CONTEE MAIN SETTLING POND DAM

PHASE I INSPECTION REPORT
NATIONAL DAM INSPECTION PROGRAM

JULY 1981

CONTEE MAIN SETTLING POND DAM
PRINCE GEORGES COUNTY, MARYLAND
NDI I.D. No. MD 81

FIELD SKETCH
CONTEE MAIN SETTLING POND DAM

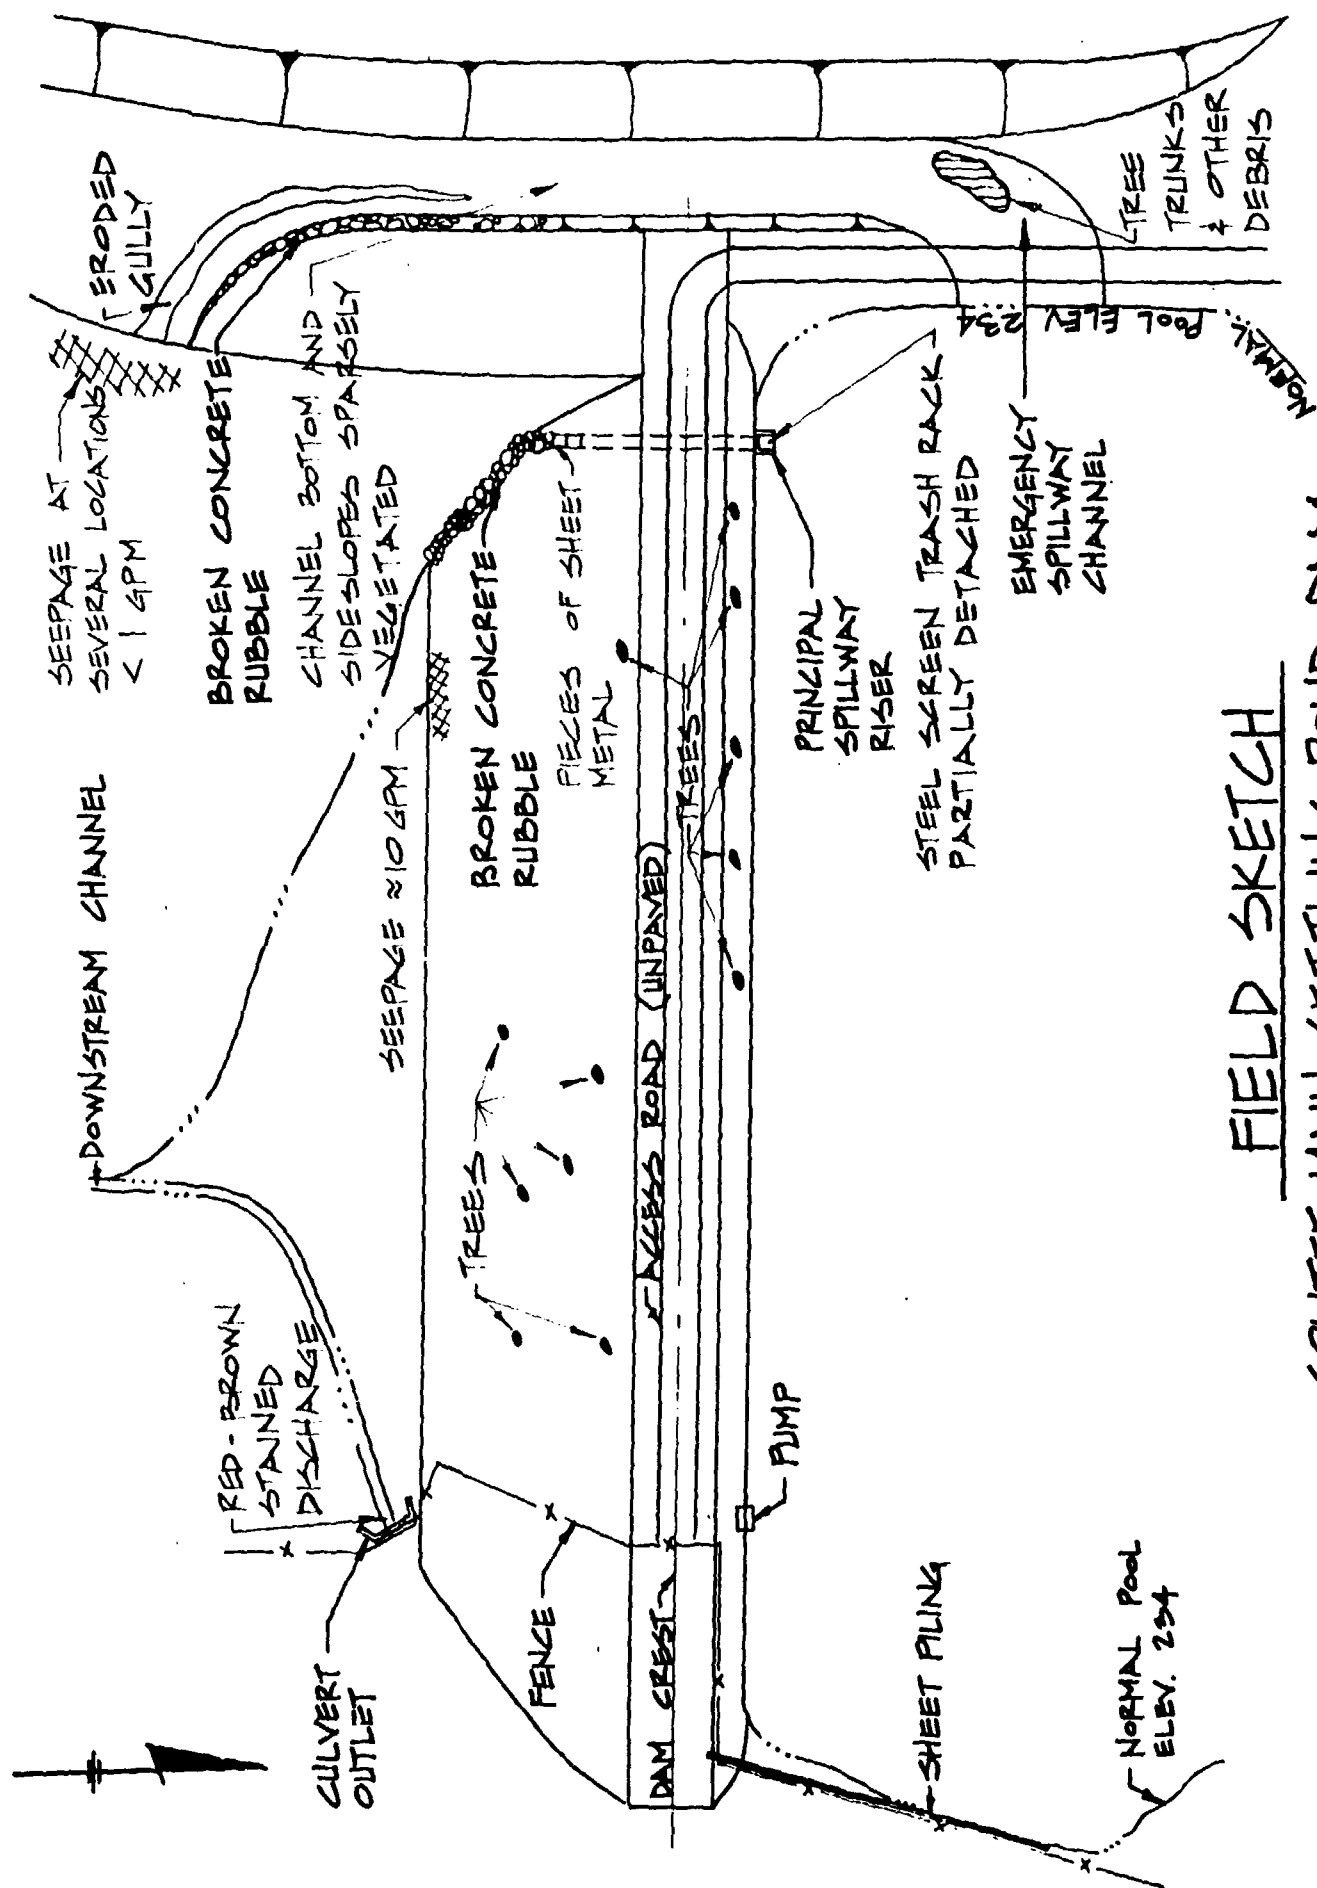
2. Monitor the seep located at the downstream embankment toe (See Field Sketch). If increased flow quantity or evidence of erosion is observed, the Maryland Water Resources Administration, Dam Safety Division should be notified immediately, and necessary corrective repairs made.

Several seeps were also noticed emanating from the right abutment at the outfall of the emergency spillway channel (See field sketch). The seepage flow from these seeps was also iron stained. The flow rate of each seep was estimated to be less than 1 gpm. No movement of soil fines or erosion channels were observed at the location of the seeps.

2. Monitor the seep located at the downstream embankment toe. If increased flow quantity or evidence of piping is observed, the Maryland Water Resources Administration, Dam Safety Division should be notified immediately, and necessary corrective repairs made.
